Southwestern Pennsylvania Road Safety Audit

**South Braddock Avenue from Meade Street to
Kenmawr Avenue / Hawkins Village**

**City of Pittsburgh, Edgewood Borough, Swissvale Borough, Rankin
Borough, Allegheny County, PA**

April 2014

Existing Drainage Grates

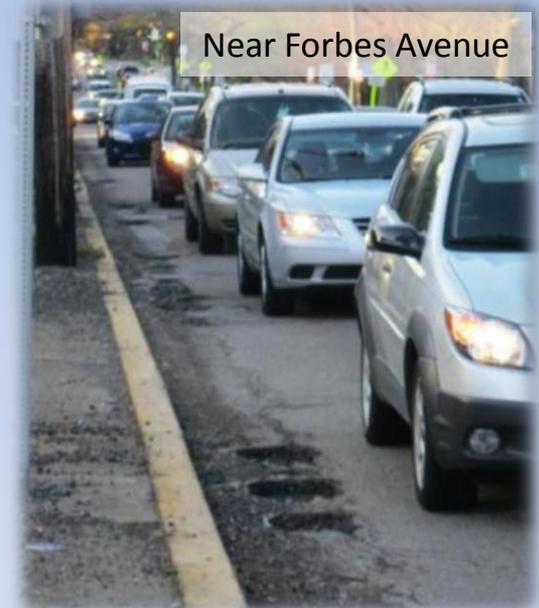
OBSERVATION: Pavement is in poor condition in a number of spots along the corridor, which can create problems for bicyclists and motorcyclists and can cause drivers to swerve unexpectedly or straddle lanes. Pavement has been built up over time resulting in little or no curb reveal and the blocking of drainage inlets. Some inlet grates are not bicycle friendly.

- Mill and resurface South Braddock Avenue and provide full height curb.
- Install bicycle safe drainage grates throughout.
- Resurface Church Street and provide an inlet on the north side to prevent water from flowing into the intersection.

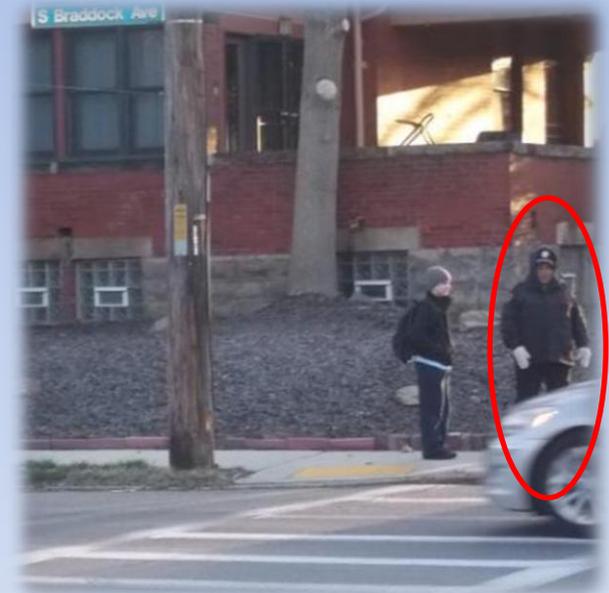
OBSERVATION: Crosswalk signage and markings are inconsistent (or non-existent in some locations). Yield to Pedestrian signs are used sporadically and placed inconsistently along the corridor. At least one crossing guard was not wearing appropriate retroreflective clothing.

- Install consistent signage at all crosswalks.
- Acquire additional Yield to Pedestrian devices and place them consistently at all unsignalized intersections.
- Ensure that crossing guards wear appropriate retroreflective clothing.
- Consider additional ped-scale lighting for enhanced nighttime visibility.

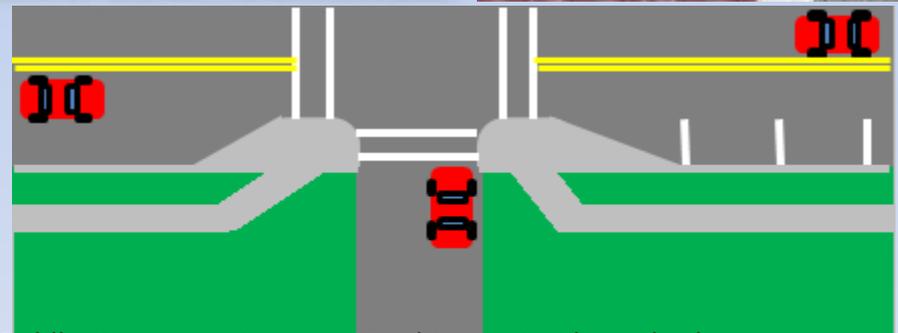
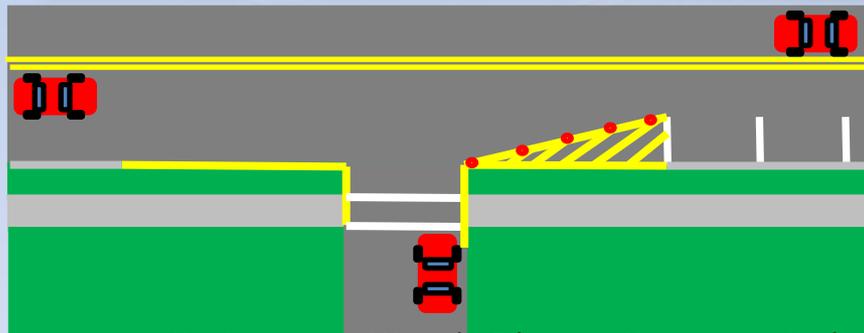
OBSERVATION: On-street parking, bus shelters, and vegetation near intersections reduces sight distances for motorists exiting side streets, can obscure pedestrians in crosswalks, and can block the view of stop signs on side street approaches.

- Restrict parking near intersections through signage and painted curbs.
- Increase parking enforcement.
- Install textured crosswalks to increase visibility.
- Consider the use of bulbouts to restrict parking at intersection corners, increase the visibility of pedestrians, and reduce crossing distances.

Gateway Signage Example:

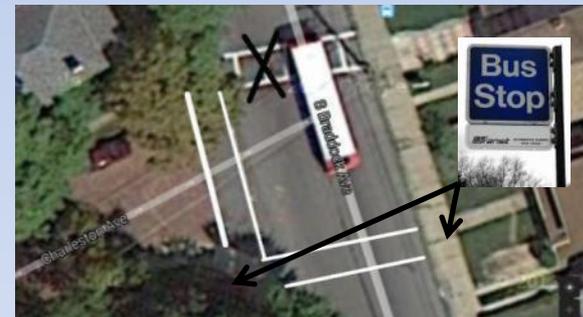
OBSERVATION: Vehicle speeds tend to be higher than desired, particularly between Sanders Street and the Parkway East. This makes it particularly difficult for pedestrians to cross the street at Charleston Avenue, which has bus stops on the north side.

- Relocate the crosswalk and bus stops to the southern side of the Charleston Avenue intersection.
- Consider “Regent Square” gateway signage as a traffic calming measure.
- Install electronic speedminder signs NB and SB to make motorists more aware of their speed.

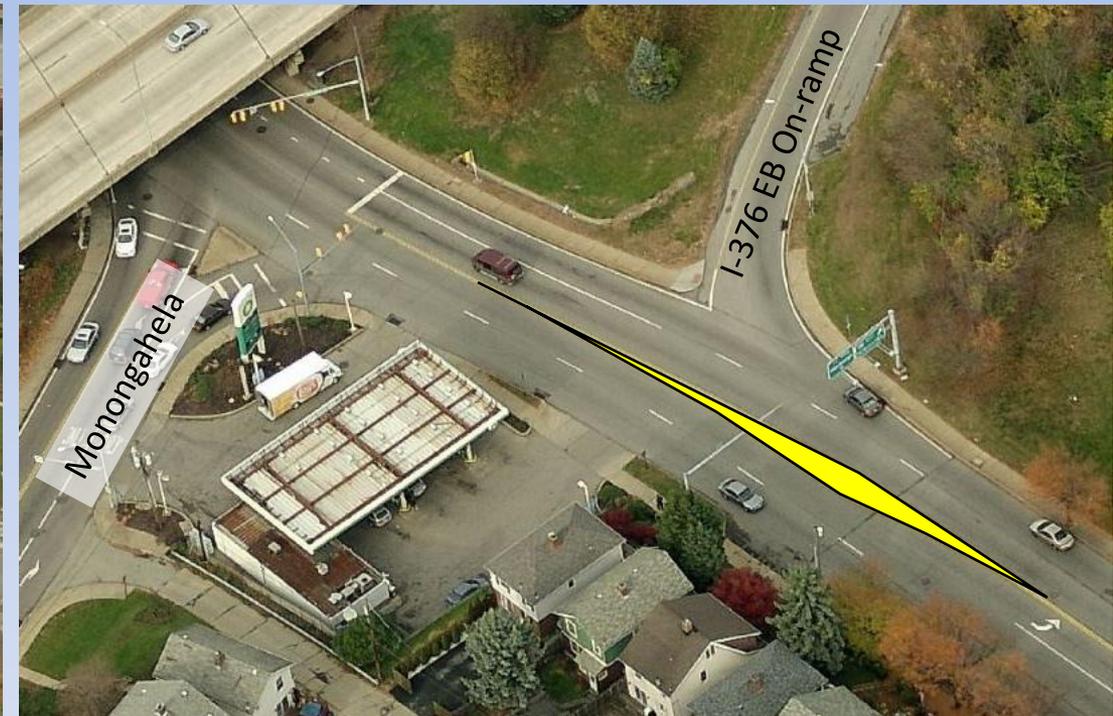
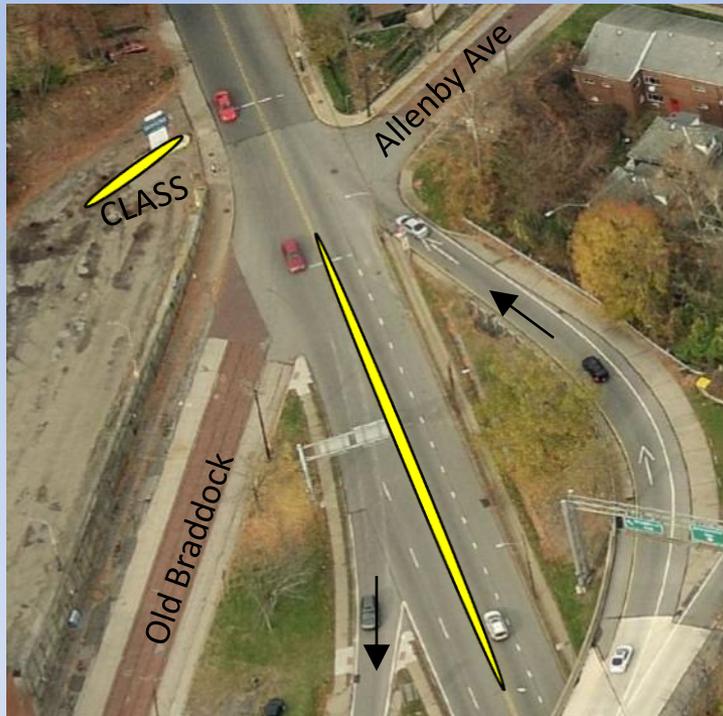
OBSERVATION: The complex interchange ramp configuration can create confusion for motorists, resulting in u-turns and other undesirable maneuvers. Ramps create many conflict points on South Braddock Avenue.

- Consider long-term modifications to the ramps including closing the EB off-ramp that outlets near Allenby and the EB on-ramp from Monongahela, realignment of the Monongahela/Braddock intersection, and addition of a SB left turn phase at this location.

- Consider long-term modifications to the ramps including changing the direction of the existing off-ramp that outlets near Allenby in order to eliminate the WB on-ramp that induces existing U-turns.

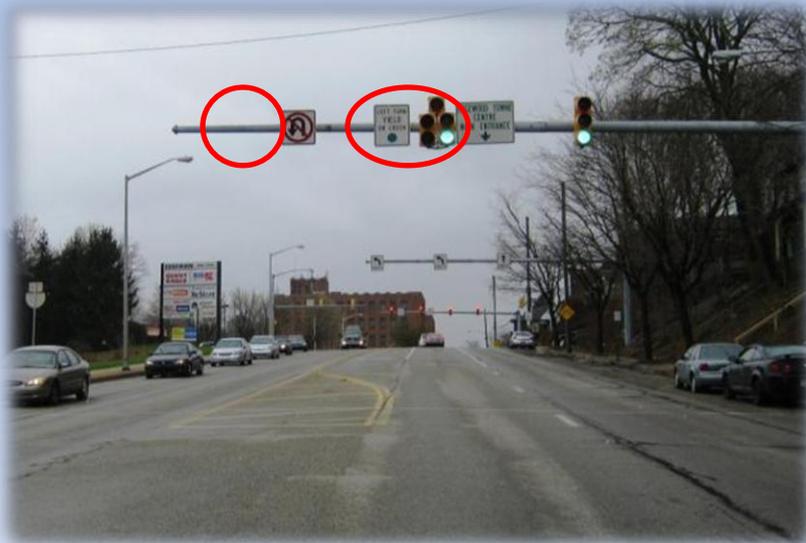
OBSERVATION: The 5-section signal head at the lower entrance to Edgewood Town Centre is not properly aligned over the left turn lane. SB through vehicles get trapped in the left turn lane for the upper entrance at times.

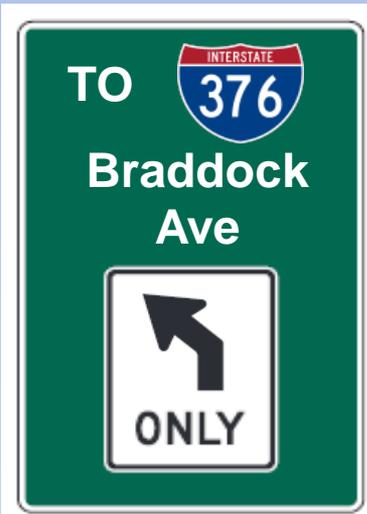
OBSERVATION: The NB overhead signage at Edgewood Avenue is faded and does not provide clear guidance to motorists.

- Simplify overhead signs.
- Change the diagonal upward arrow on the I-376 sign at the intersection to a downward diagonal arrow.

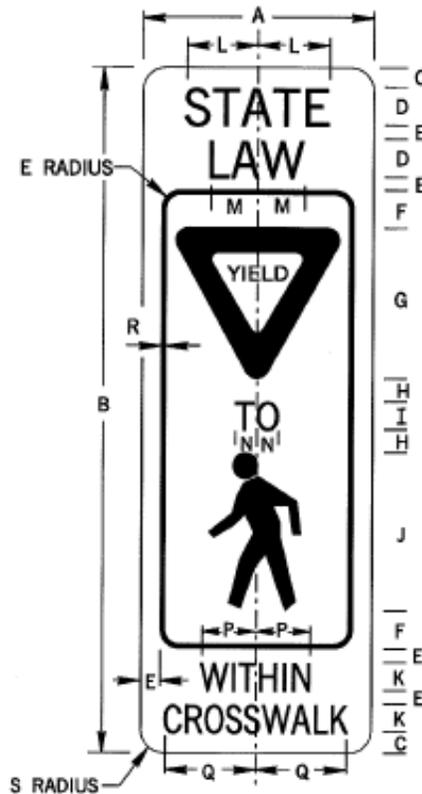
Note: The distance from the Charter School property to the corner of South Braddock and Henrietta Street is approximately 150'. The distance from Henrietta Street to Biddle Street (middle of intersection to middle of intersection) is approximately 405', and from Biddle to Guthrie is an additional 550'. The distance from Henrietta Street to Overton Street (middle of intersection to middle of intersection) is approximately 660'.
